Re: 1321 NE Country Lane
Lot 6, Fritchie Bluff

Apex Engineers, Inc. observed the framing for the house located at the address above. Our firm was retained to address a structural issue noted during the rough-in inspection.

Job Address: 1321 NE County Lane Sheet # 1 of 3
Summit

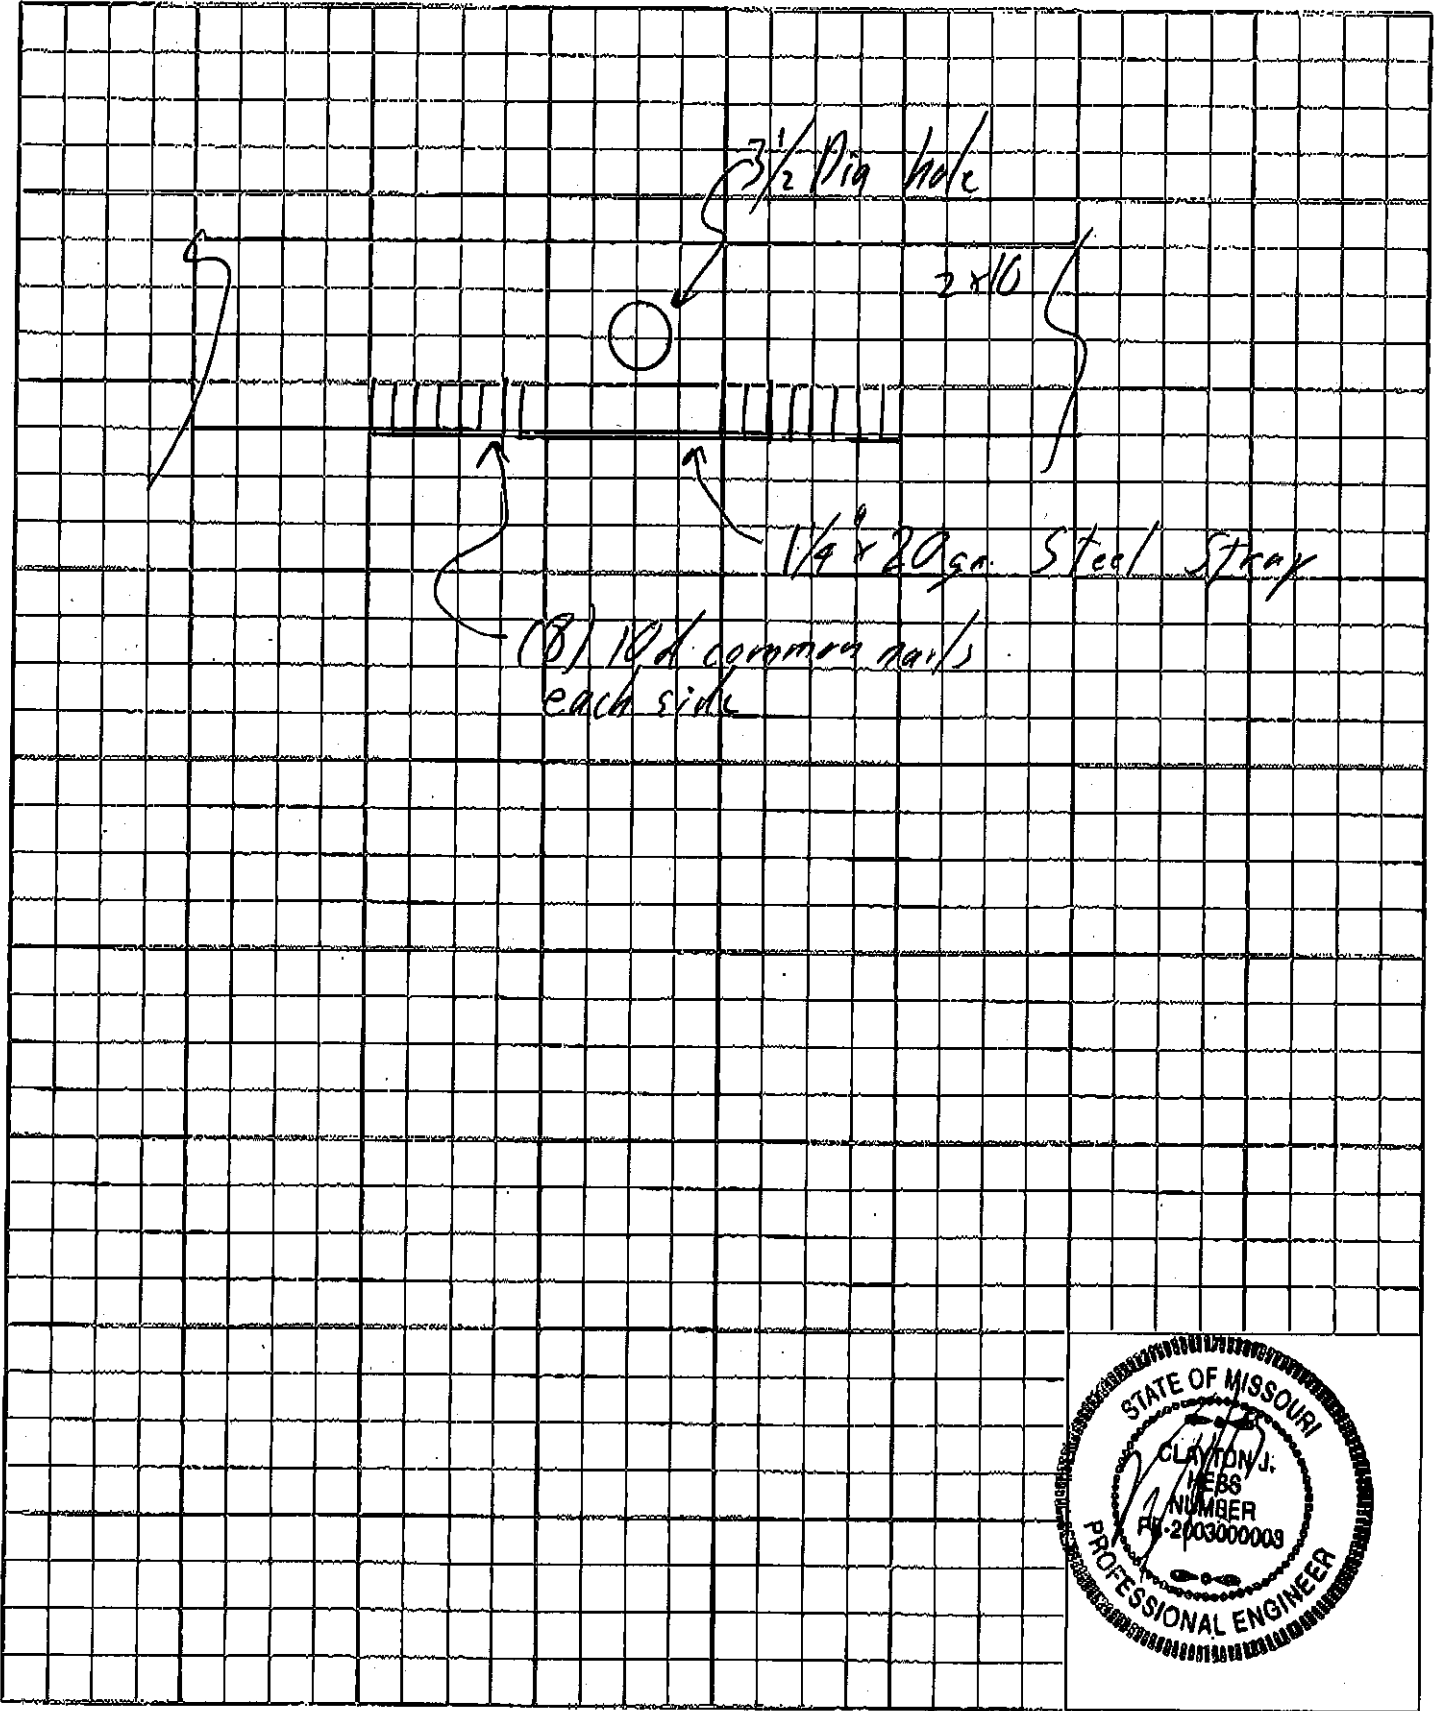
Several floor joists were bored with a larger diameter hole than allowed by code. The holes are 3-1/2" in diameter and are a minimum of 2" from the bottom of the joist. One of the joists was severed and headered off to the adjacent joists. After computations, our firm recommends the following:

- The floor joists on either side of the severed joist need to be doubled.
- Centered under each 3-1/2" diameter hole, fasten, to the bottom of the joist, a 1-1/4" wide, 36" long by 20 gauge steel strap (Simpson CS20) with a minimum of (8) 10d common nails on each side of the hole. See attached sketch for clarity.
